Title & Document Type: HP 339A Operating and Service Manual

Manual Part Number: 00339-90001

MODEL 339A

DISTORTION MEASUREMENT SET

Figure 8-14. Fundamental Rejection Circuit.
8-15/8-16

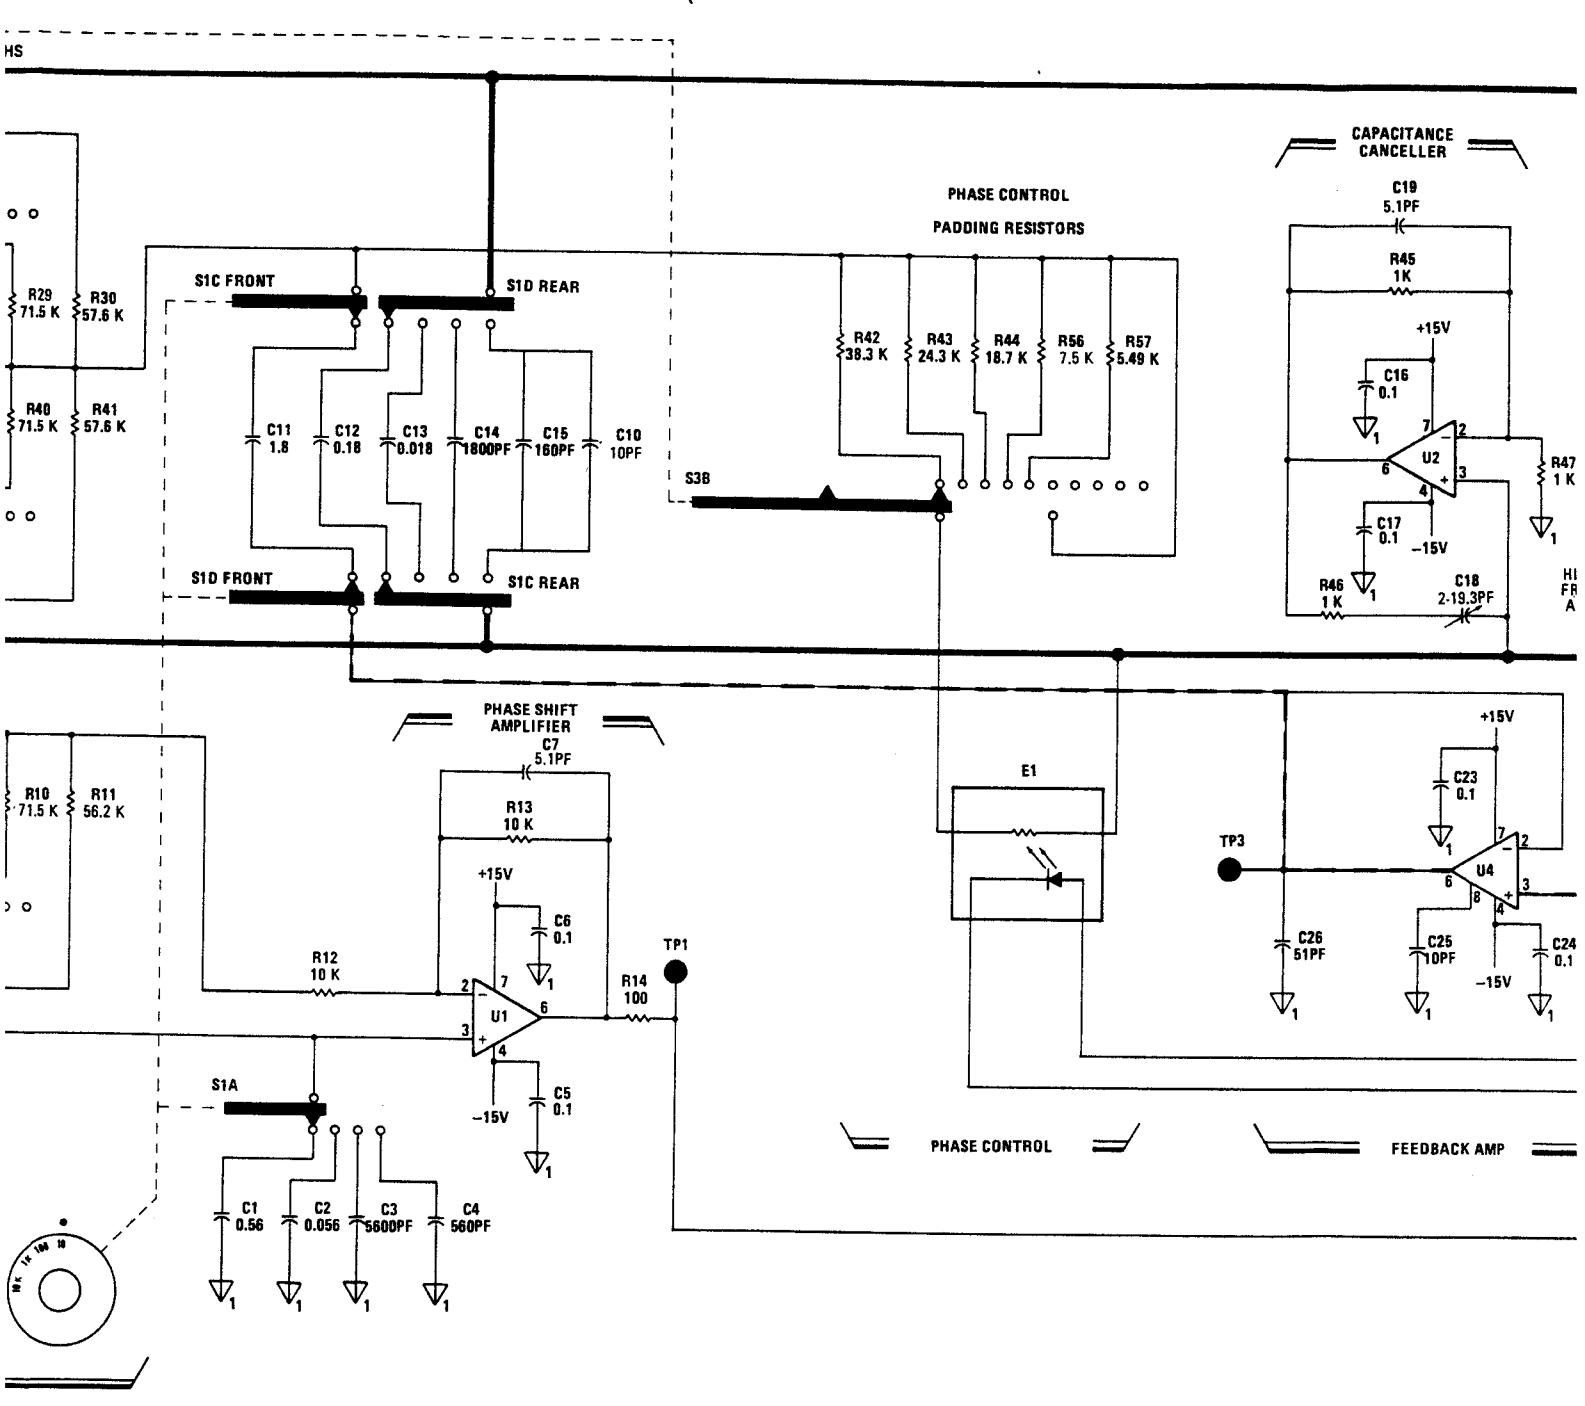
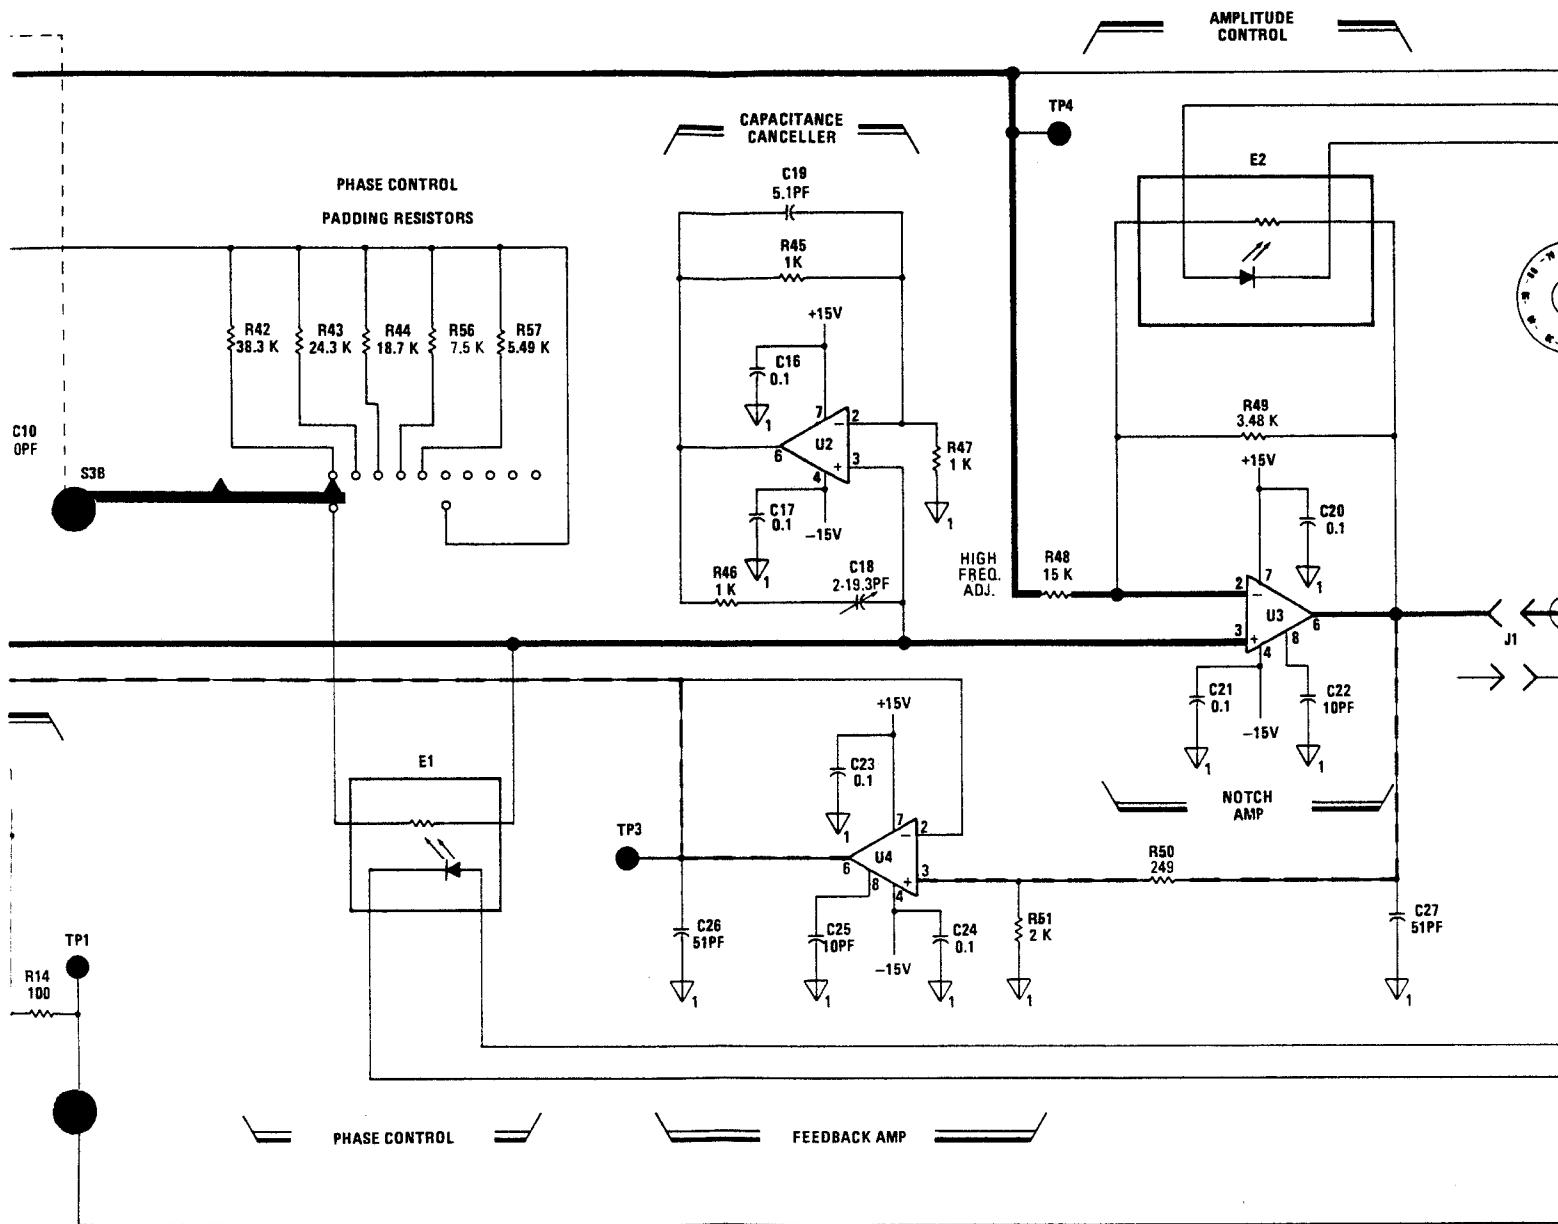
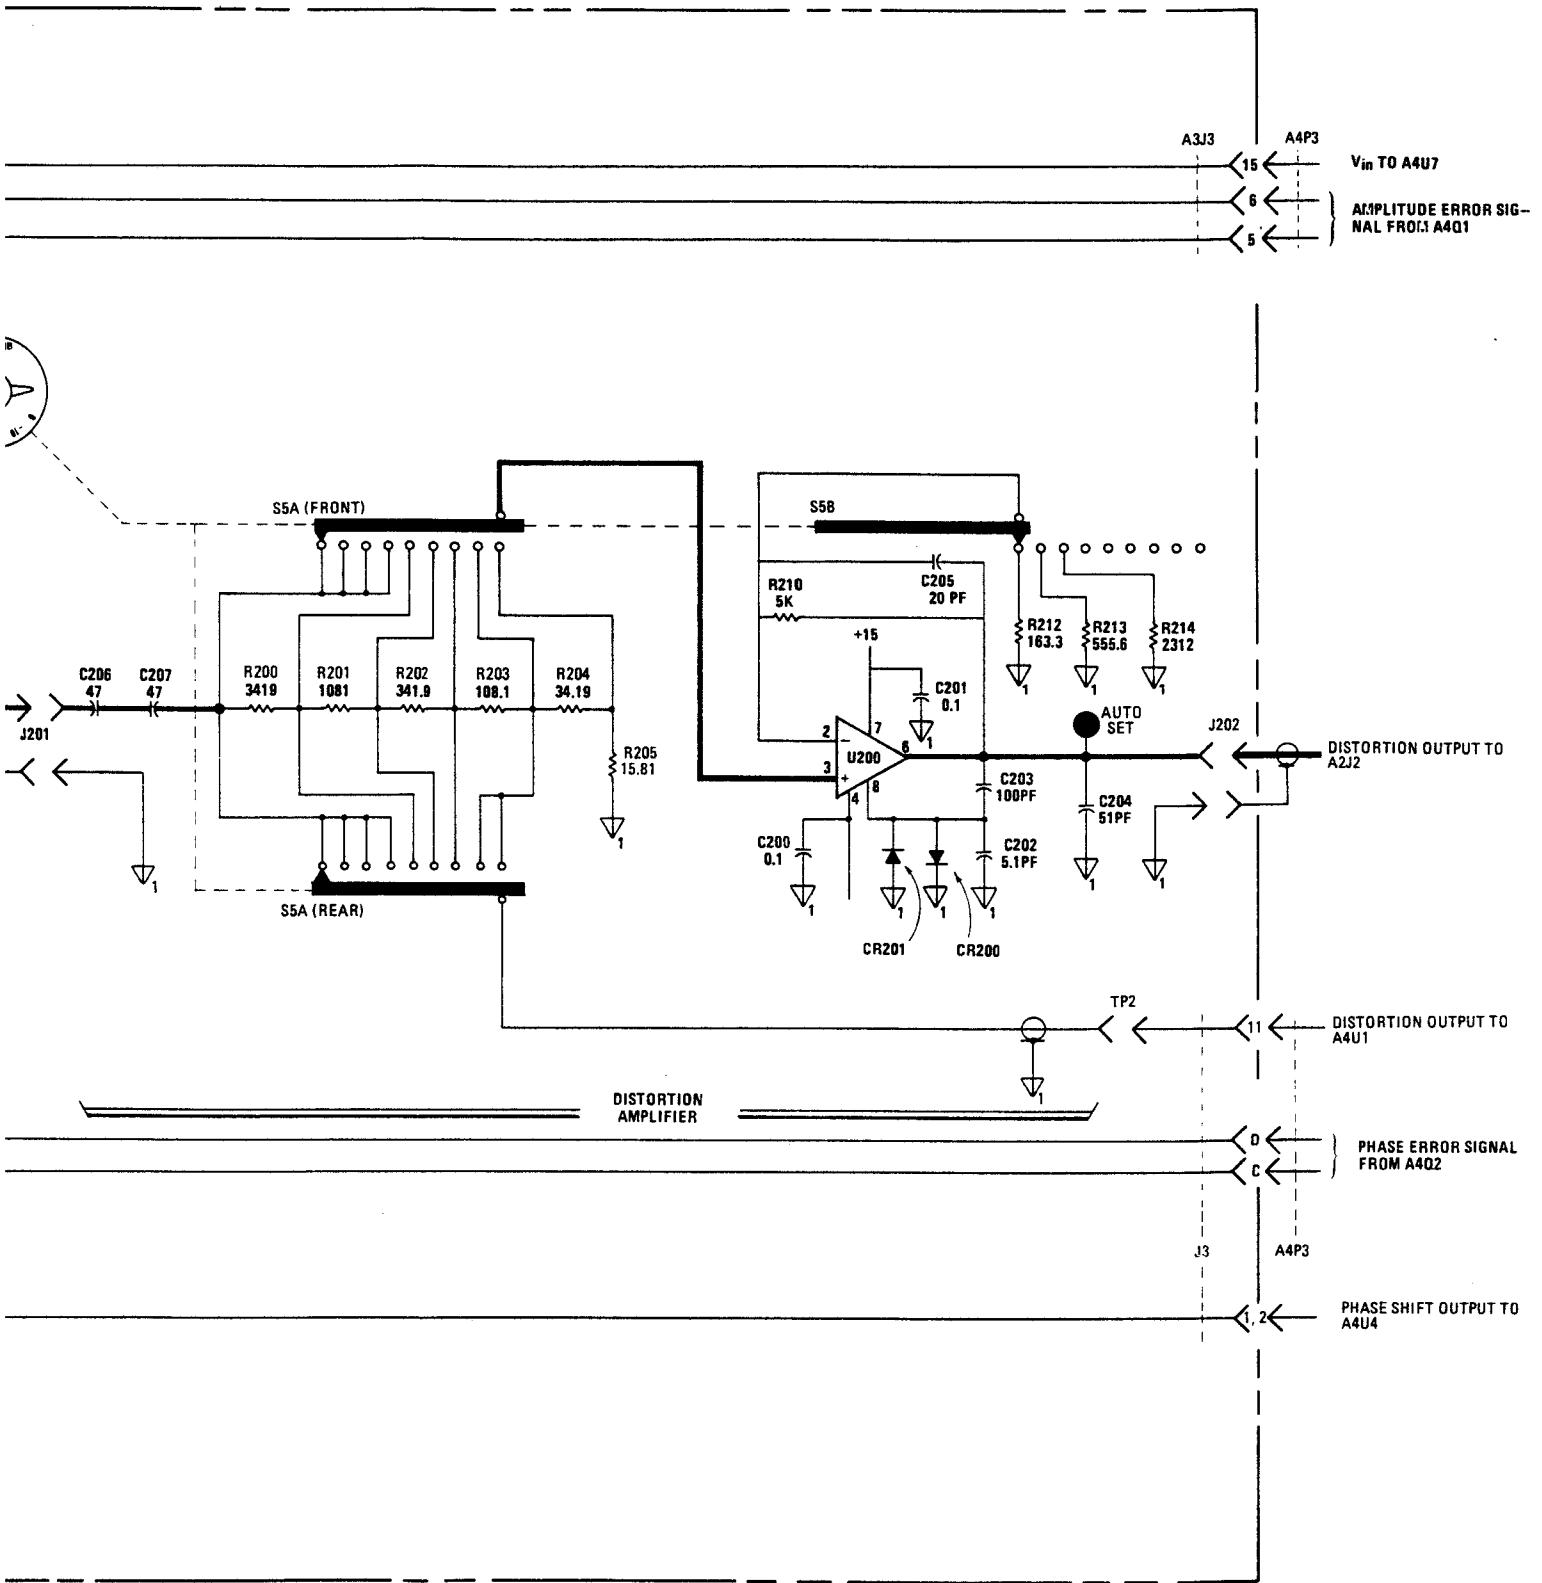
Page 8-15/8-16, Figure 8-14. Add R60, a 10k variable resistor, in series with A3E1 photoresistor.

Page 8-15/8-16, Figure 8-14. Remove R60 and replace with a wire jumper.

Page 8-15/8-16, Figure 8-14. Change the schematic values of the resistors above as shown. Add C28, value 20pF in parallel with R49.

Page 8-15/8-16, Figure 8-14. Change the value of C205 from 20pF to 43pF.

Page 8-15/8-16, Figure 8-14. Change the value of C205 from 43pF to 20pF.

Page 8-15/8-16, Figure 8-14. Delete schematic symbols, values, and designators for C202, C203, C204, CR200, and CR201.

Page 8-15/8-16, Figure 8-14. Replace C204, CR200 and CR201 where they were in the schematic originally.
